MIL ON With DTCs P0AA649 and/or P1C8049 or AM Radio Static/Distortion

Service Category Engine/Hybrid System

Section Hybrid/Battery Control System

YEAR(S)	MODEL(S)	ADDITIONAL INFORMATION
2019 - 2021	RAV4 HV	VDS(s): BWRFBV, D6RFBV, DWRFBV, E6RFBV, EWRFBV, L6RFBV, LWRFBV, M6RFBV, MWRFBV, R6RFBV, RWRFBV

Figure 1. Image of HV Floor Under Wire Pathway Through Vehicle

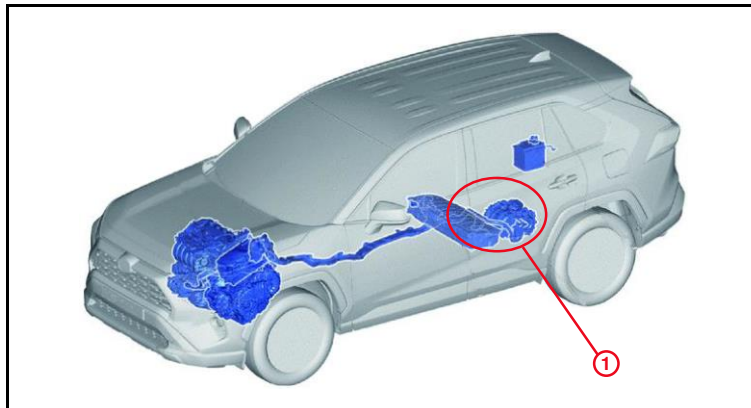
The vehicle may also exhibit static or distortion when listening to AM radio. These conditions may be caused by corrosion on the high-voltage wire harness below the vehicle at connector Y6 at Motor Generator Rear (MGR) or dirt and debris inside the connector. Follow the Repair Procedure in this bulletin to address these conditions.

1	Area of Concern
----------	------------------------

4. Replace the HV Floor Under Wire.
